Clause 104 Modifications for 10SPE - Baseline

HEATH STEWART

► Modify Table 104-8 SCCP Electrical Requirements

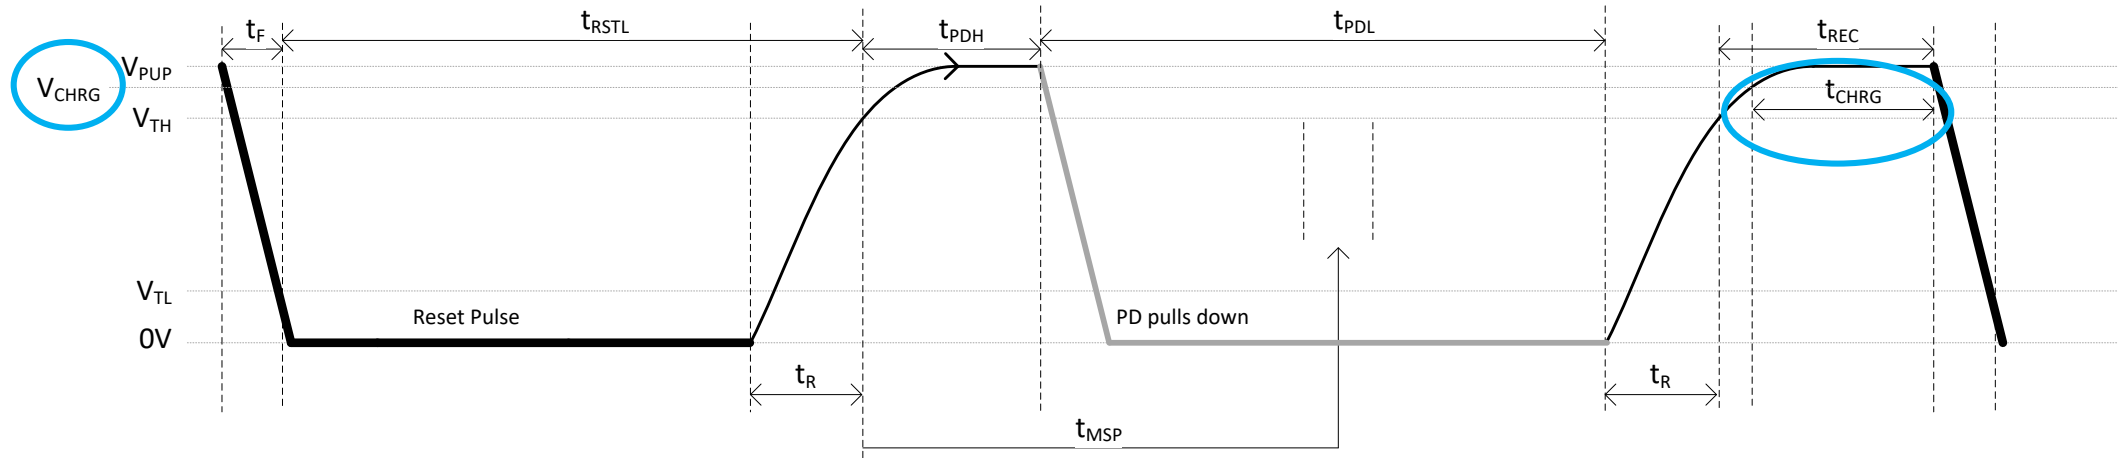
- Change existing items to Type A, B, C, D (new column)
- Split existing t_{SLOT} into two variants (update figures 104-11,12)
 - $t_{\text{WRITESLOT}}$, using existing t_{SLOT} value
 - t_{READSLOT} , using existing t_{SLOT} value
 - Delete t_{SLOT}
- All following changes attributable to New 10SPE Type 'E'
 - If item already exists split row, existing row is Type A, B, C, D
 - Split C_{BUS} , add subrow 72nF for Type E
 - Add clarity for PD reservoir capacitor recharge for Type E
 - Create $V_{\text{CHRG, min}} = V_{\text{PUP, min}} * 90\%$
 - Create $t_{\text{CHRG, min}} = 200\mu\text{s}$
 - Add all bold red changes as shown in slides 5, 6, 7 (sorry about color choice)
 - Attribute to Type E
 - Split rows

Reset command timing proof

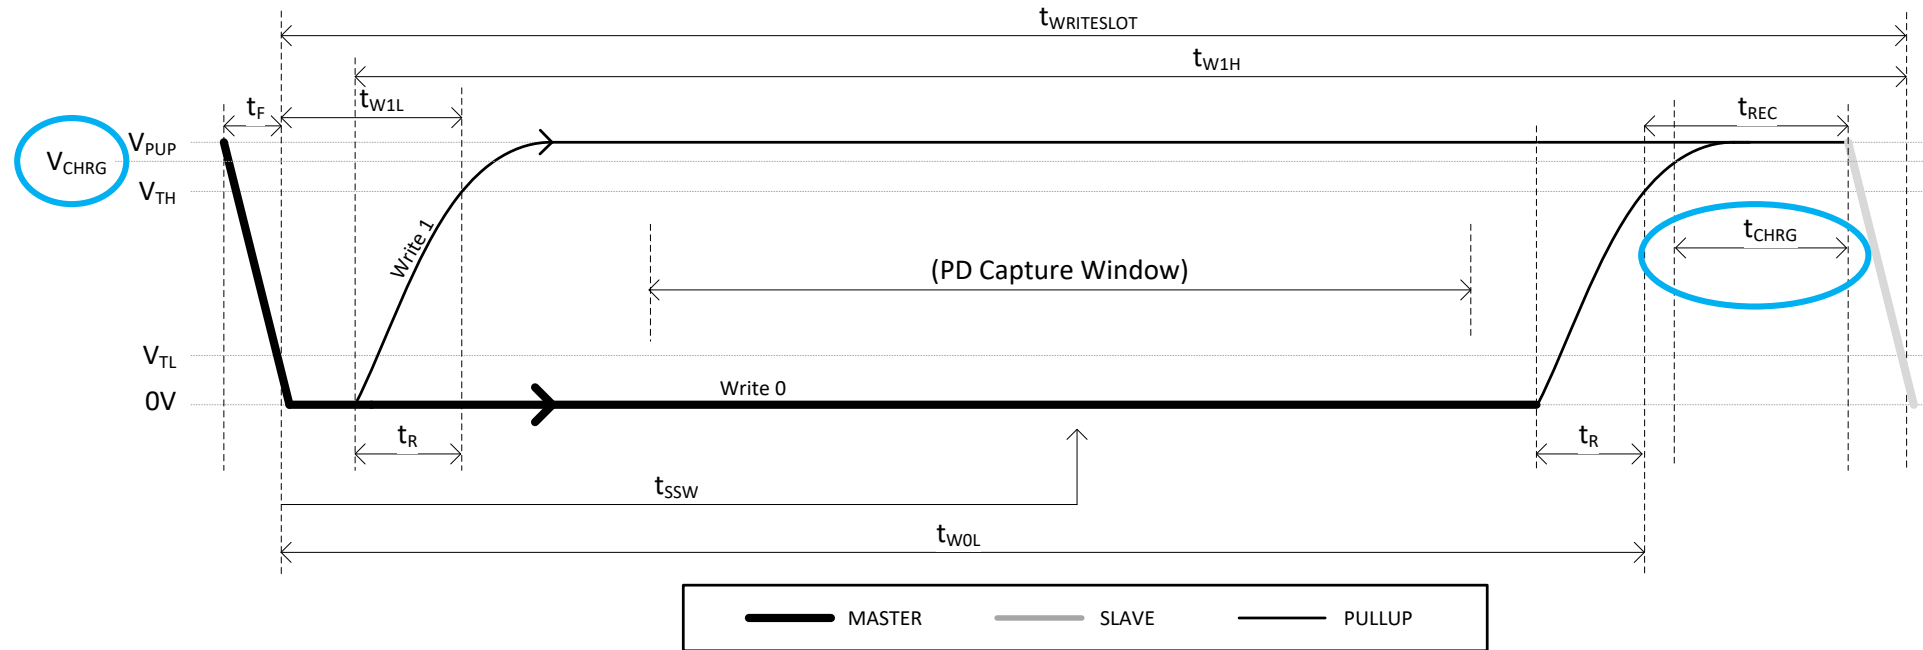
- ▶ Change Figures 104-10,11,12
 - Add V_{CHRG} , t_{CHRG} as shown in slides 5, 6, 7

Symbol	Min	Typ	Max	Unit	Note
t_F			250	us	5V pu vs 100Ohm pd
t_R			500	us	9mA PSE pu / $0.4\mu F C_{chan}$ V_{TL} to V_{CHRG}
t_{RSTL}	8	9	10.5	ms	PSE LO time for Reset pulse
t_{PDH}	0.7	1.0	1.3	ms	PD HI, measured from rising edge V_{TH}
t_{PDL}	2.8	4.0	5.2	ms	PD LO, presence pulse, pulldown duration
t_{MSP}	1.8	2.0	2.2	ms	PSE presence capture, measured from rising edge V_{TH}
t_{REC}	270	300	330	us	Charge PD SCCP reservoir capacitor
t_{CHRG}	200			us	Critical PD SCCP reservoir capacitor charging region
$t_{SLOT,RST}$			18.6	ms	
t_{LO}			10.5	ms	PD must maintain state

Red indicates changed parameters
Bold indicates parameters captured in SCCP electrical requirements

Write 0/1 slot timing proof

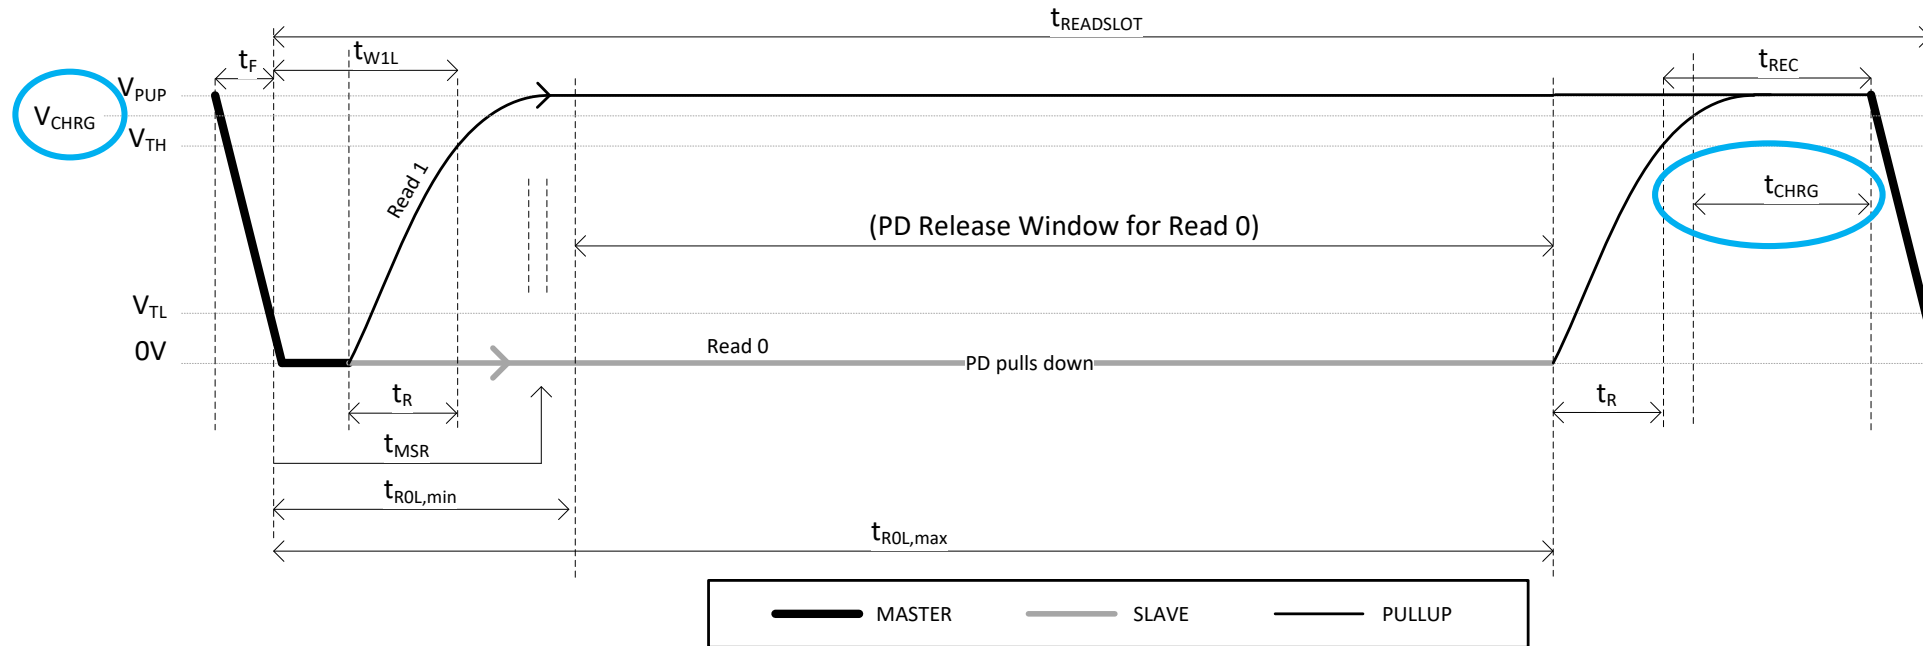
Symbol	Min	Typ	Max	Unit	Note
t_F			250	us	5V pu vs 100Ohm pd
t_R			500	us	9mA PSE pu / $0.4\mu F C_{chan}$ V_{TL} to V_{CHRG}
t_{W1L}	90		610	us	
t_{SSW}	0.77	1.1	1.43	ms	PD capture measured from falling edge V_{TL}
t_{WOL}	1.8	2.0	2.2	ms	PSE hold time for Write 0 symbol
t_{REC}	270	300	330	us	Charge PD SCCP reservoir capacitor
t_{CHRG}	200			us	Critical PD SCCP reservoir capacitor charging region
$t_{WRITESLOT}$			2.78	ms

Red indicates changed parameters
